2	01.07.14	Submission for S75W	EC
1	27.06.14	Submission for S75W	EC
Revision	Date	Description	Initial

Site 3 - Australia Towers II
Sydney Olympic Park
Plan
Ground Level

Site 3 - Australia Towers II Sydney Olympic Park

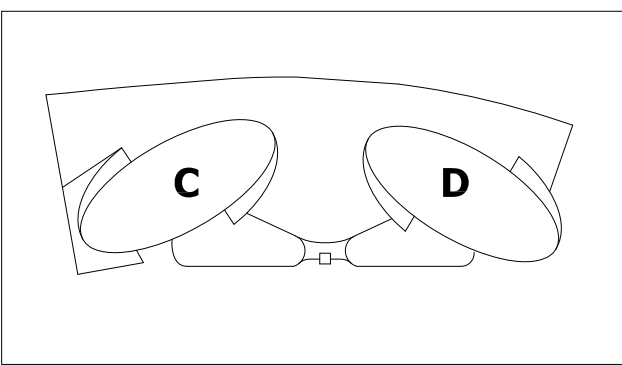
- Retail area revised
- Mail box room revised
- Main lobby layout revised

Site 3 - Australia Towers II
Sydney Olympic Park
Plan
Level 01

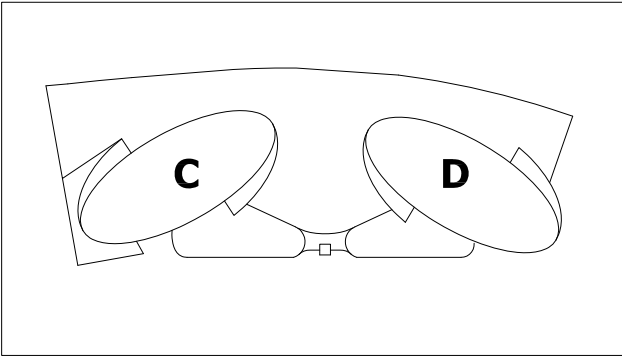
- Commercial lots revised
- Stairs revised

GA Plan - C - Level 24

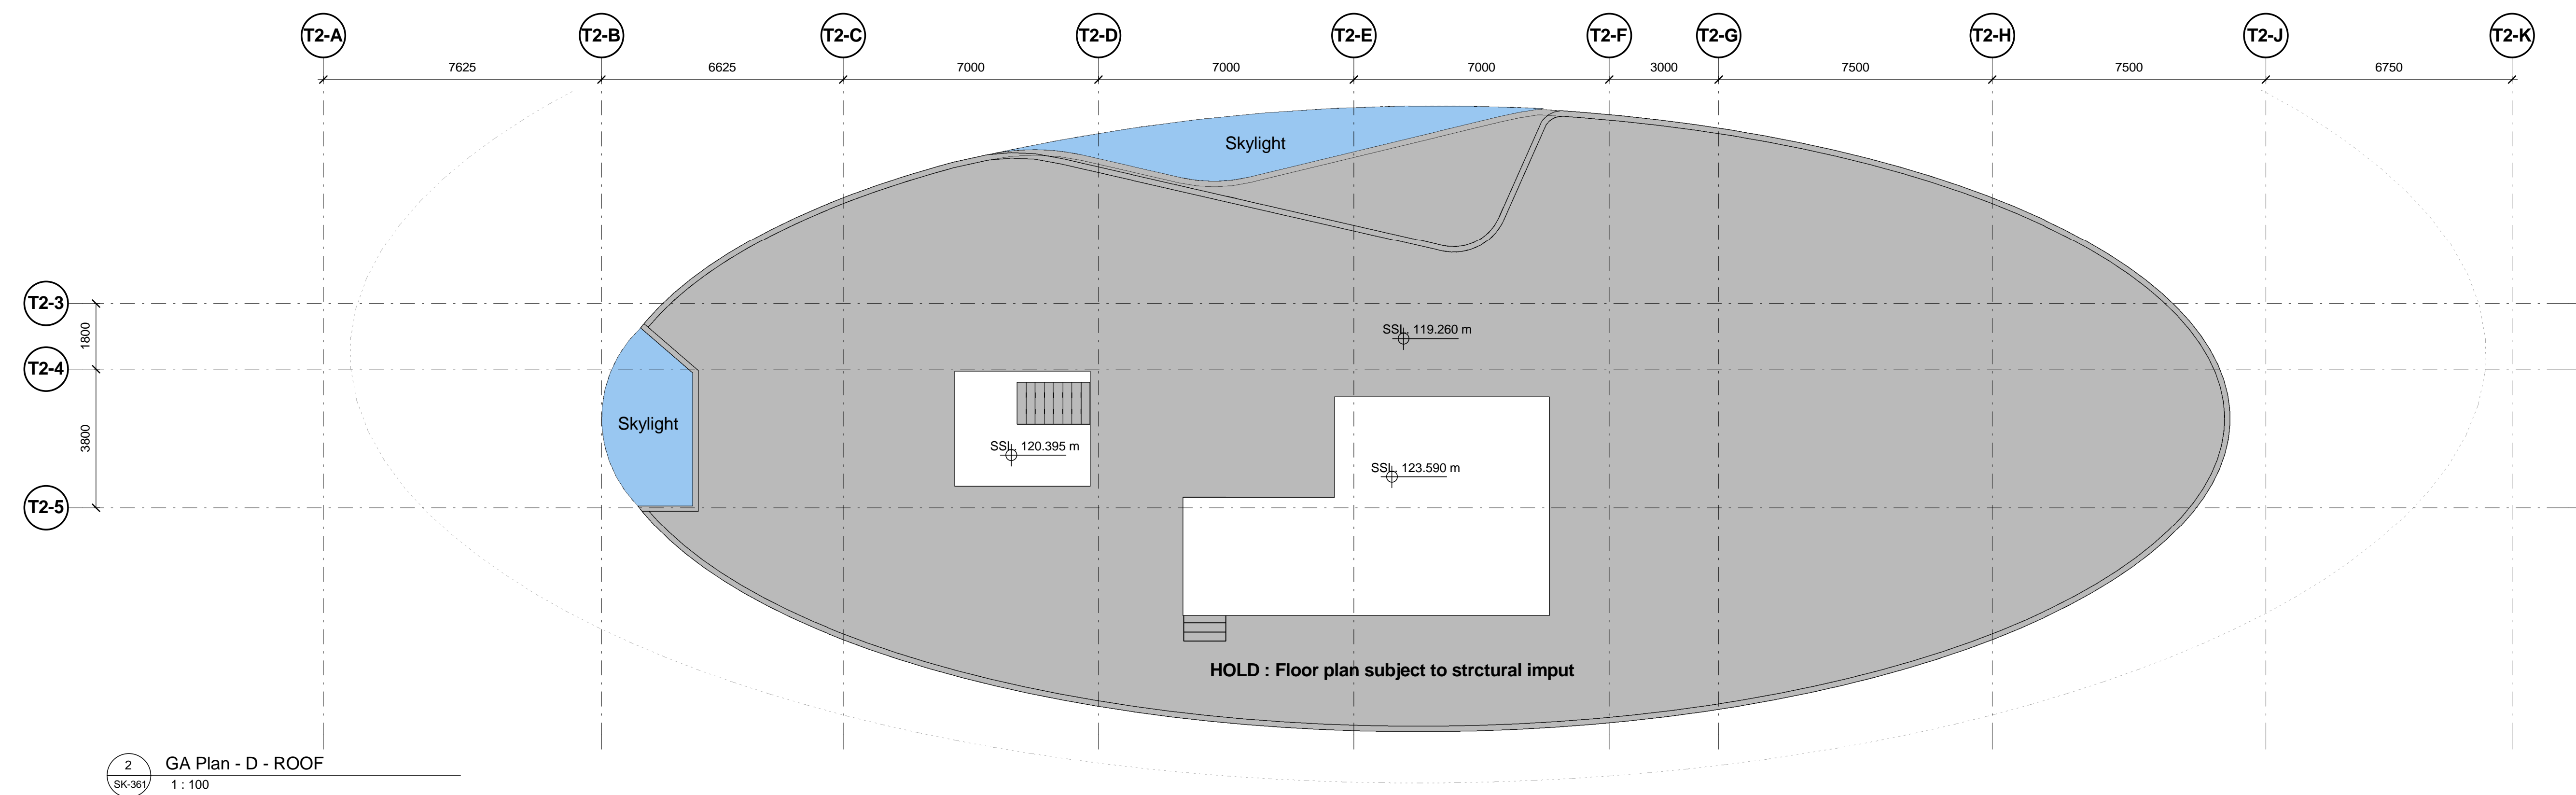
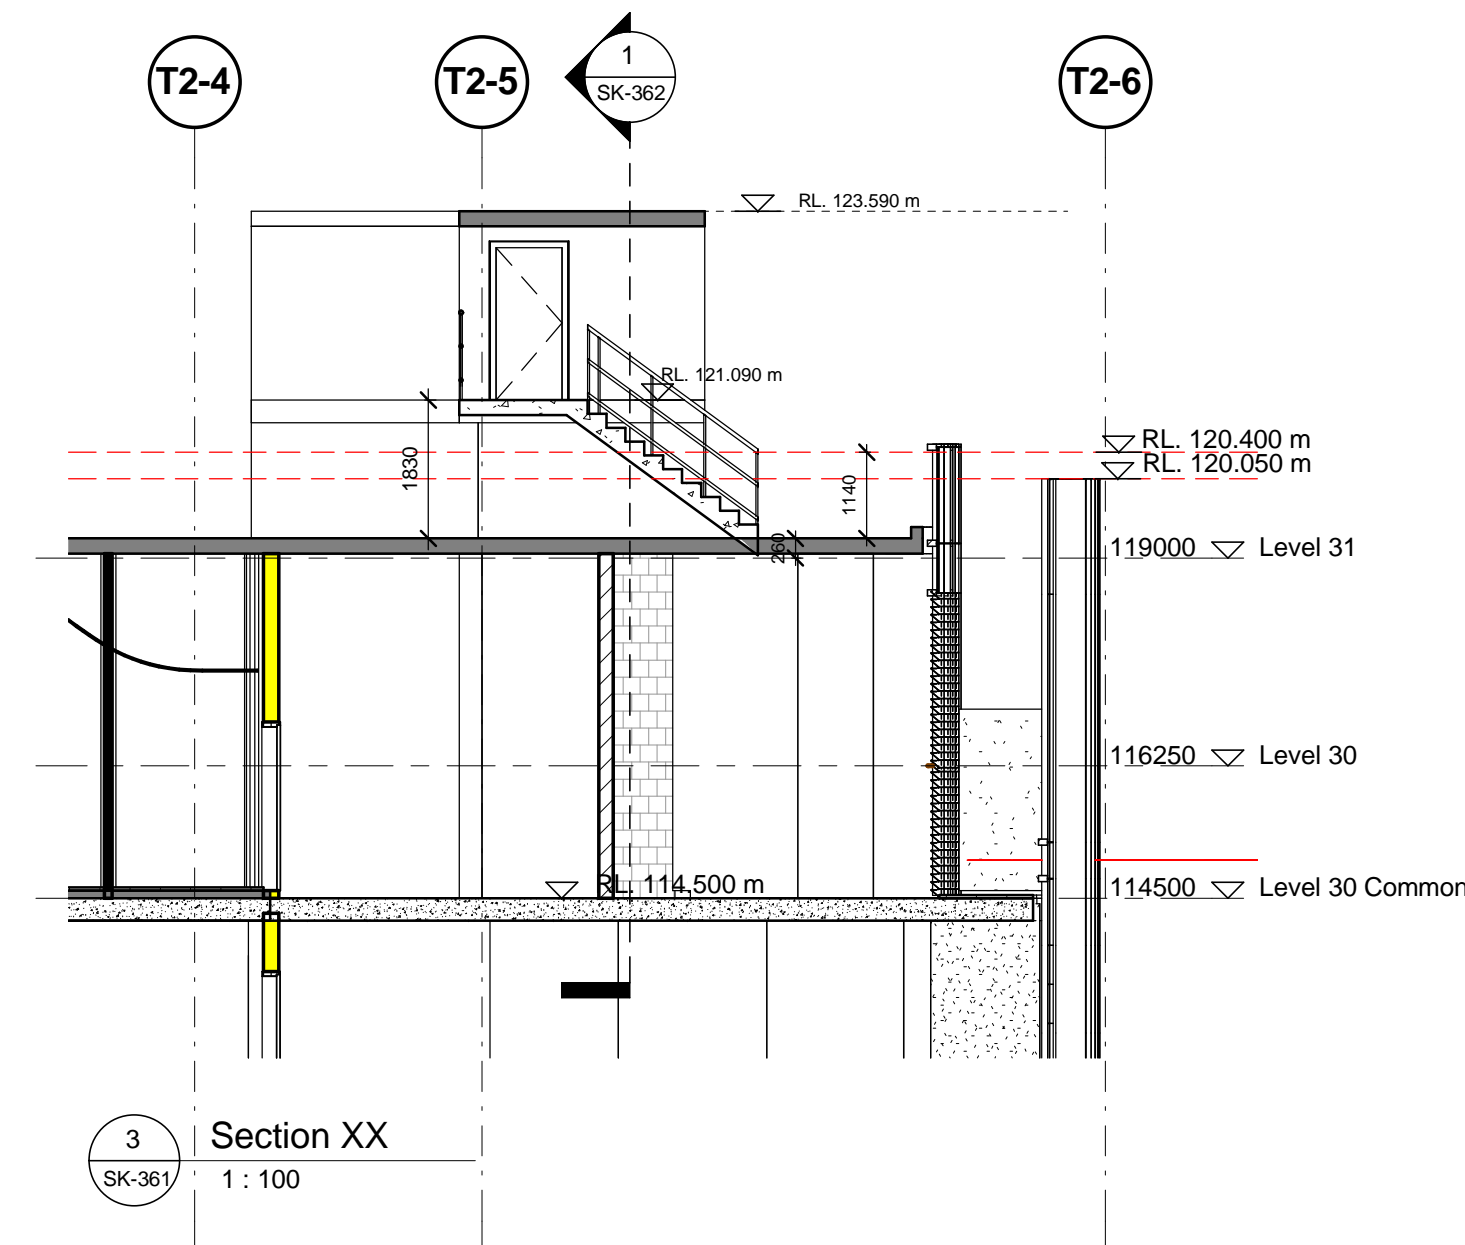
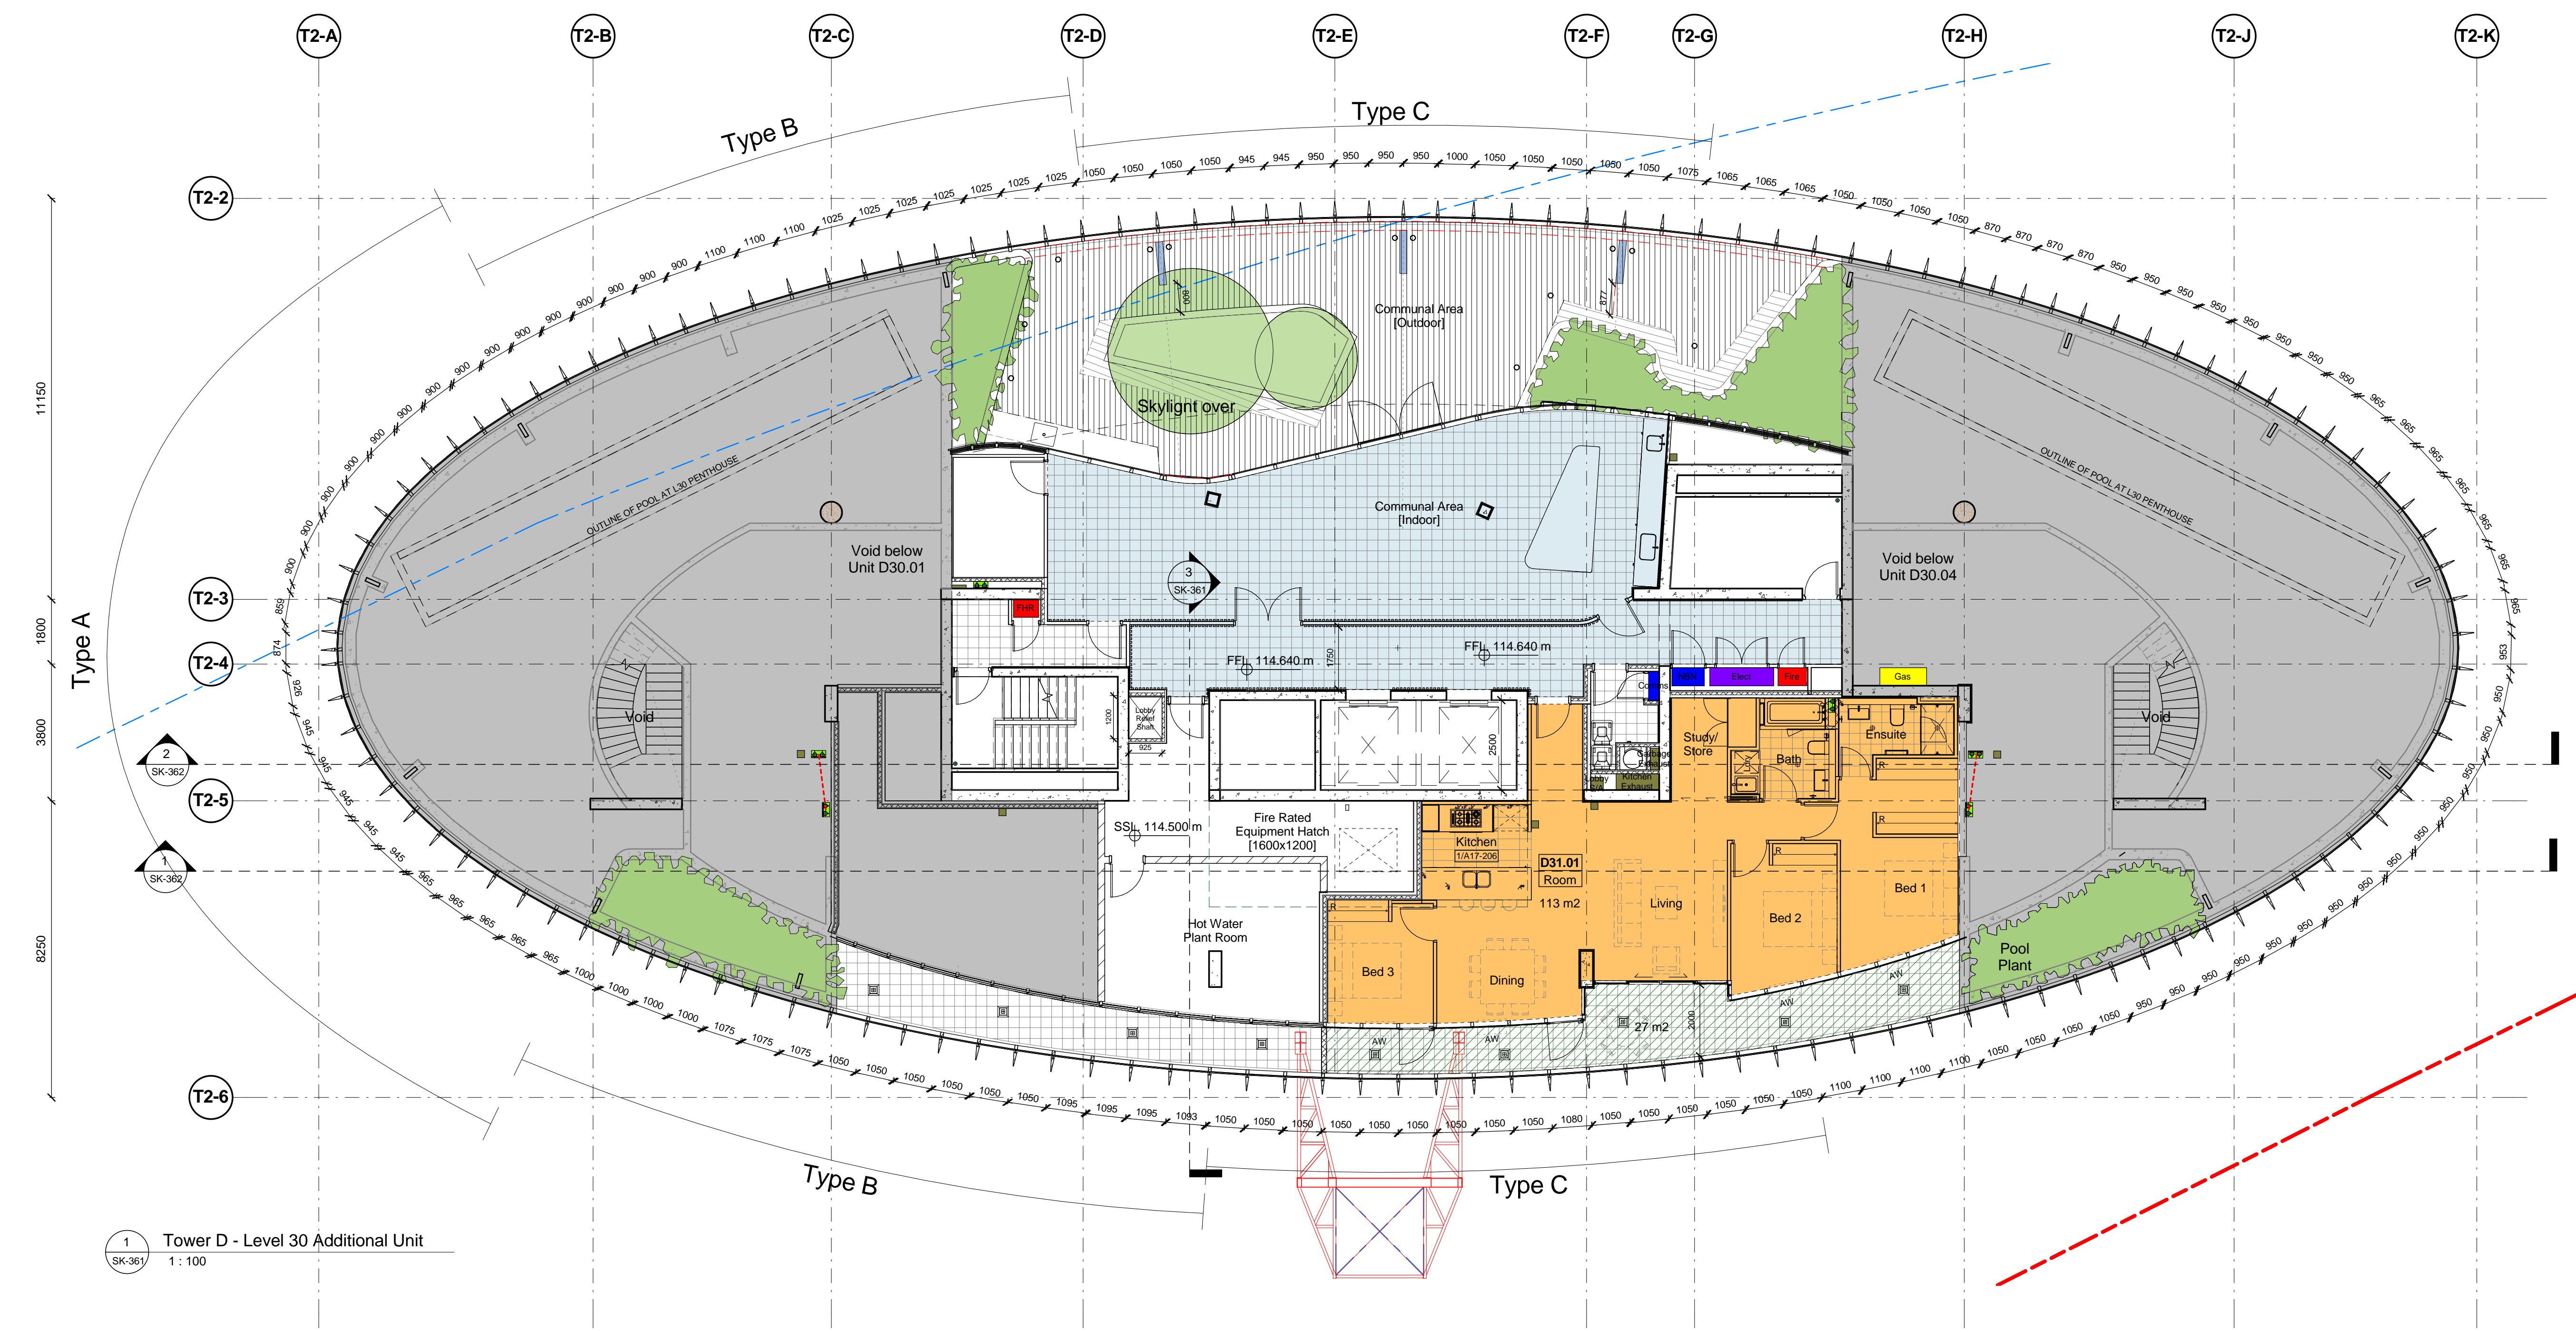
Additional HC & GPO as per VD072. Setout as per typical vertical arrangement.

Notes:
 - Additional apartment units - C25.08 and C25.09
